Sent: 22/04/2021 7:36:47 AM
Subject: 12 Ponsonby Parade Seaforth NSW 2092 DA 2021/0008 WRITTEN
SUBMISSION: LETTER OF OBJECTION #2 Submission: Twigg & Crabb
Attachments: Twigg Crabb Submission 22 April 21.docx;

a written submission by way of objection to DA 2021/0008

Re:
12 Ponsonby Parade Seaforth NSW 2092
DA 2021/0008

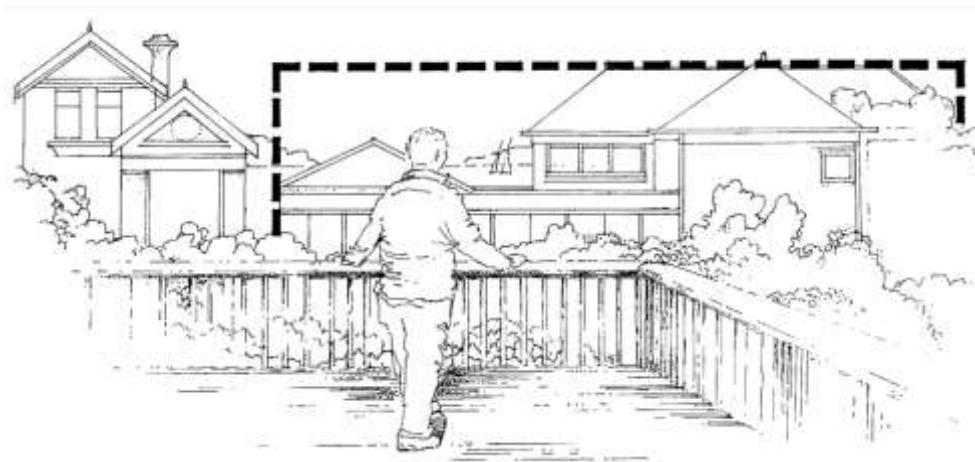
The planning principle states that consideration should be given to the causes of the visual impact and whether they are reasonable in the circumstances.

The fourth step is to assess the reasonableness of the proposal that is causing the impact. A development that complies with all planning controls would be considered more reasonable than one that breaches them. Where an impact on views arises as a result of non-compliance with one or more planning controls, even a moderate impact may be considered unreasonable. With a complying proposal, the question should be asked whether a more skilful design could provide the applicant with the same development potential and amenity and reduce the impact on the views of neighbours. If the answer to that question is no, then the view impact of a complying development would probably be considered acceptable and the view sharing reasonable.

Figure 10 - Shadow effect

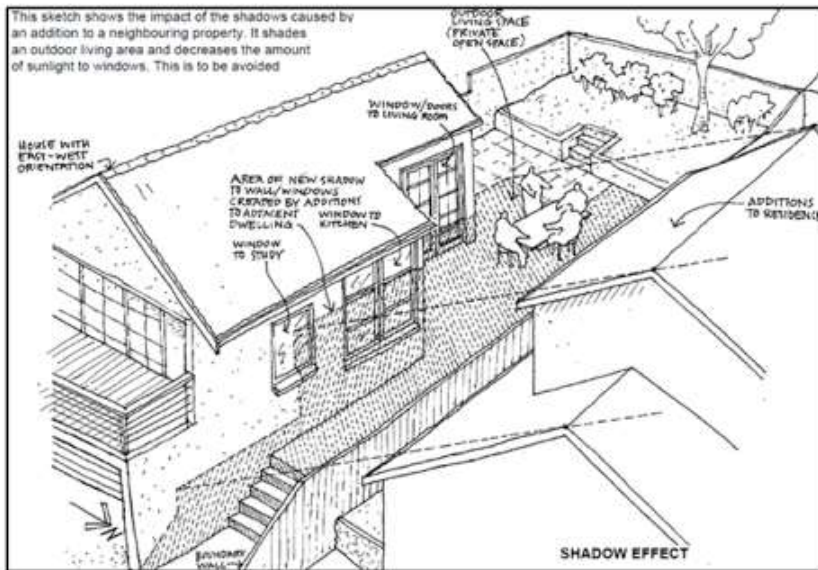
We ask for a compliant 8.5m maximum building height, and compliant side setback to allow more reasonable solar access.

We ask Council to obtain from the Applicant hourly overshadowing morning elevational drawings of our northern windows.
